A meeting of the **WAVERLEY DEVELOPMENT ASSESSMENT PANEL** will be held will be held in the Community Room at the Margaret Whitlam Recreation Centre, Bondi Road, Bondi Junction at:

12.00 PM WEDNESDAY, 25 JULY 2018

20-24 Hall Street, Bondi Beach – Partial demolition of heritage listed building (Australia Post Office) and construction of a four storey mixed use development containing 2 basement levels of car parking, ground level retail with 10 residential units above (DA-475/2017)

Report dated 16 July 2018 from the Development and Building Unit.

WINTER GARDENS:
GLAZING INFORMATION

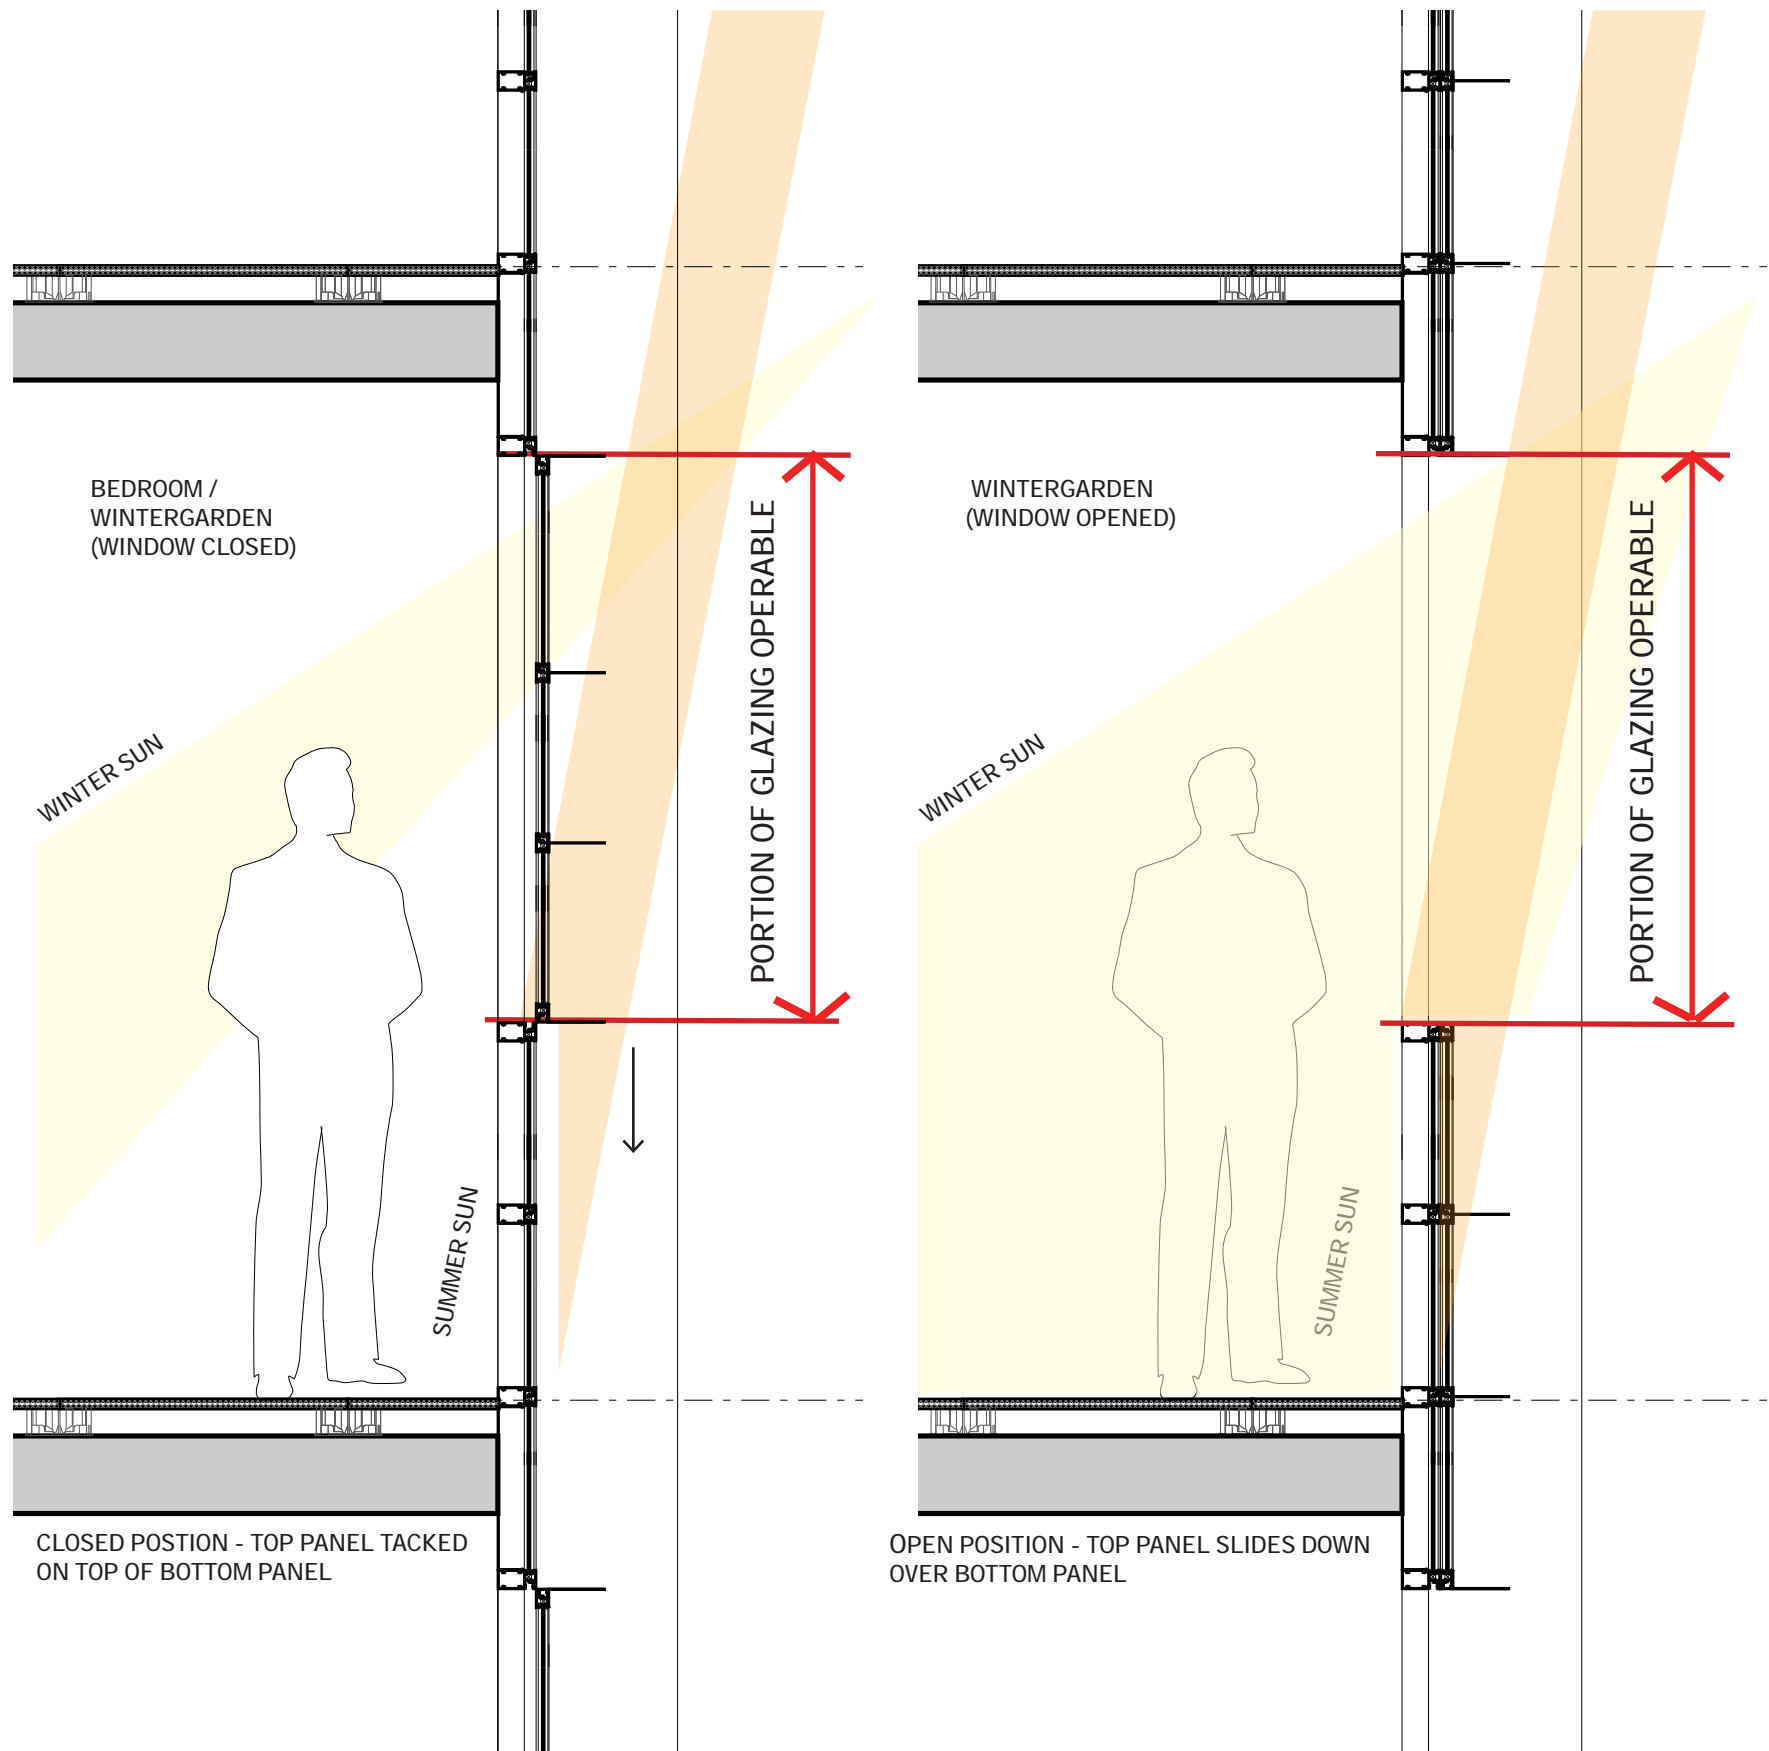
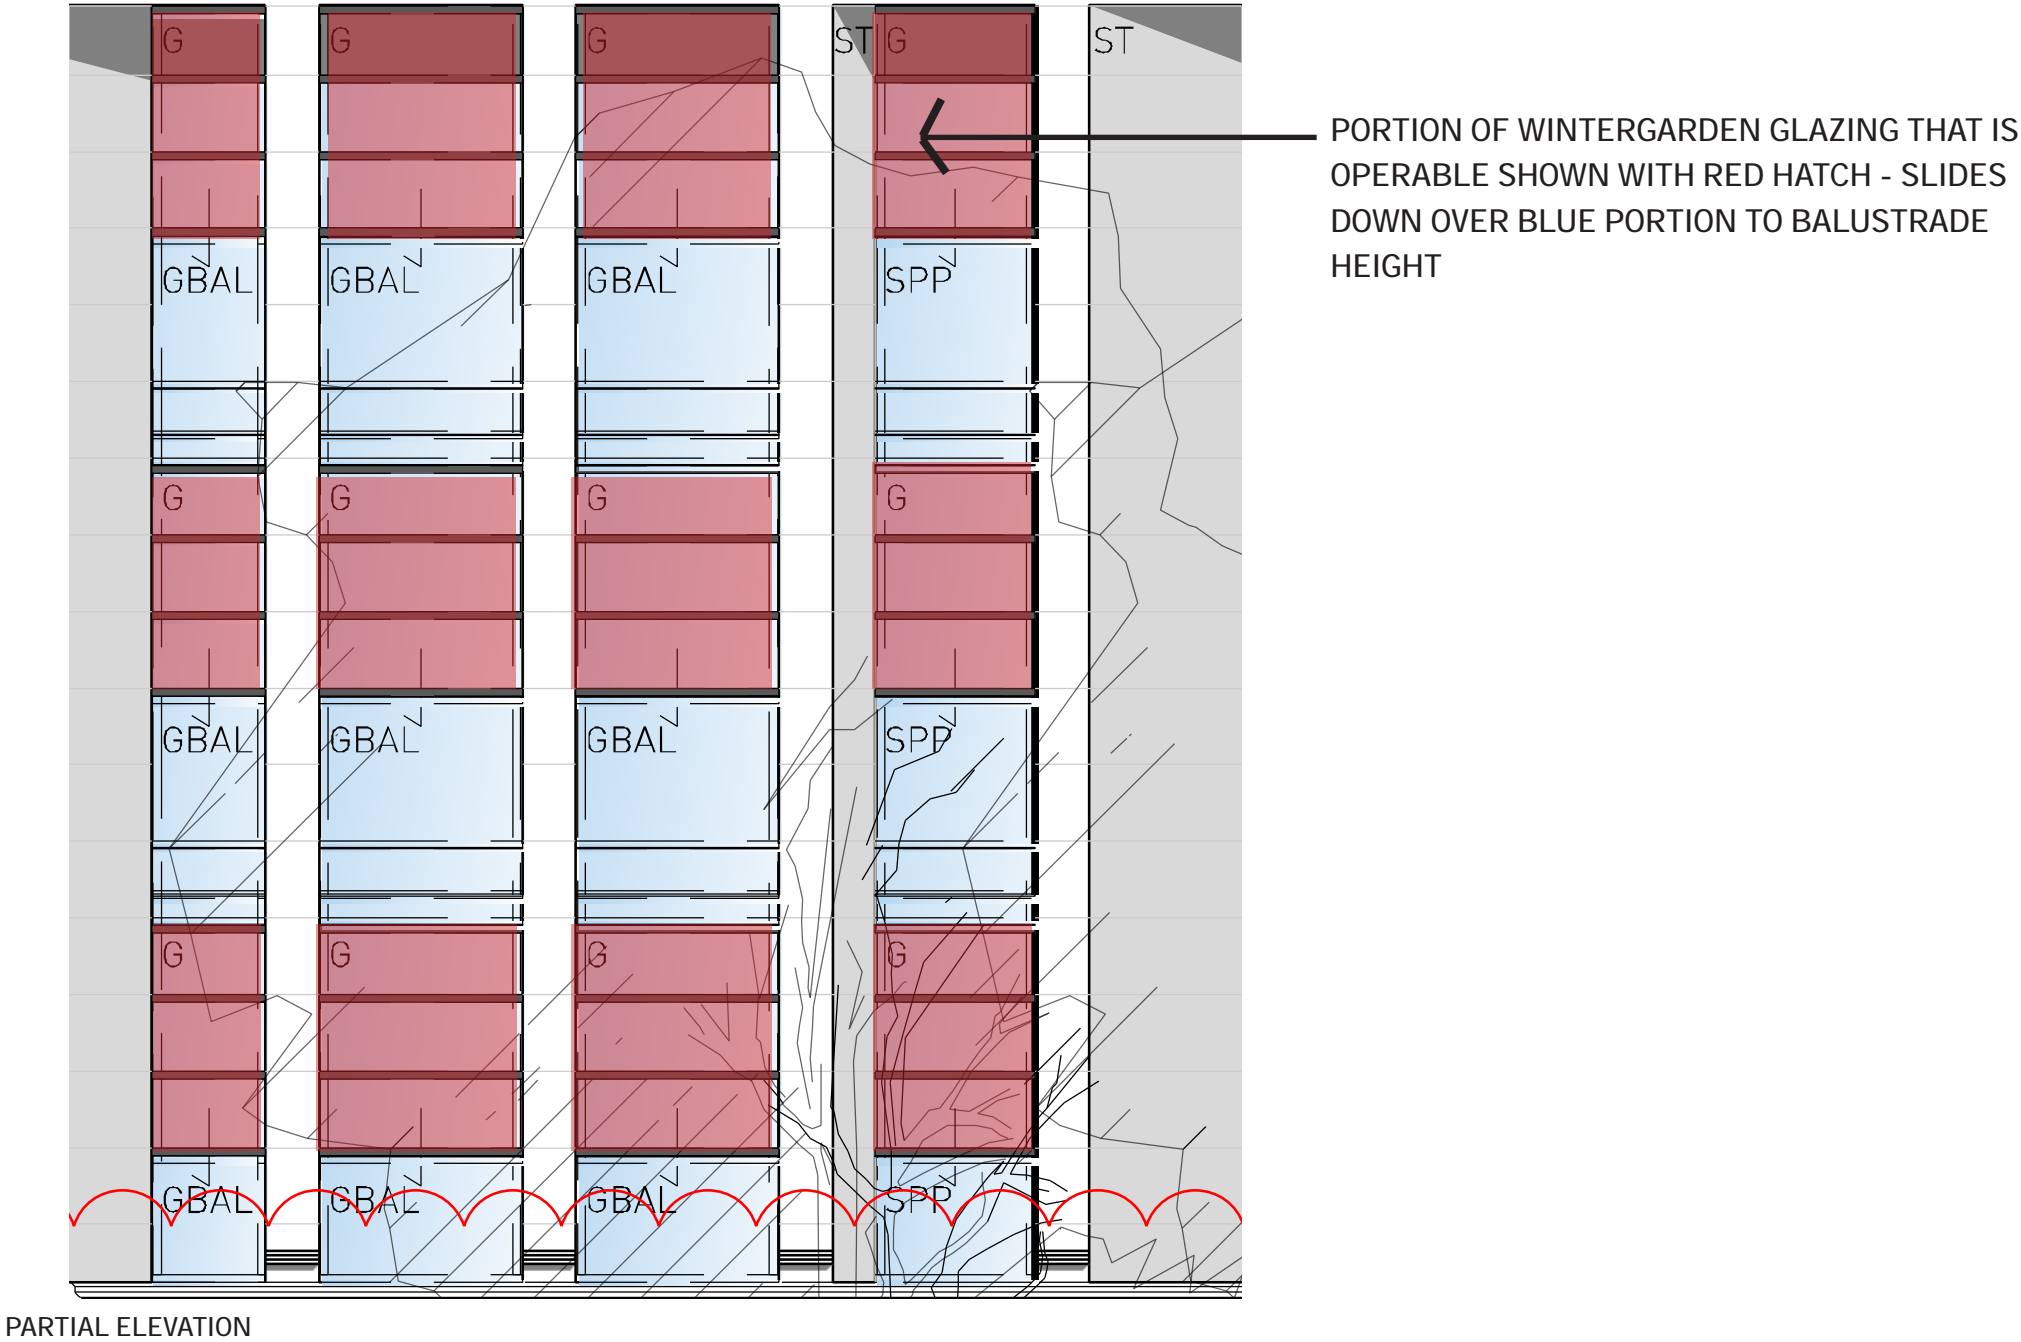
- During the assessment process, the applicant was asked to provide further information about the winter gardens and how they were to be enclosed and which portion of the glazing was operable. The applicant provided sketches and sections to indicate that the portion of glazing that is operable sits above the balustrade and is able to slide down over the bottom panel to provide a balcony-like space when desired. While the wintergardens will be included in the GFA calculations, they are less enclosed than other designs and able to operate as a balcony when required.

The operation of the windows is that the entire top portion of the windows slides down over the bottom fixed portion of the window

When open, the window then acts as a balustrade
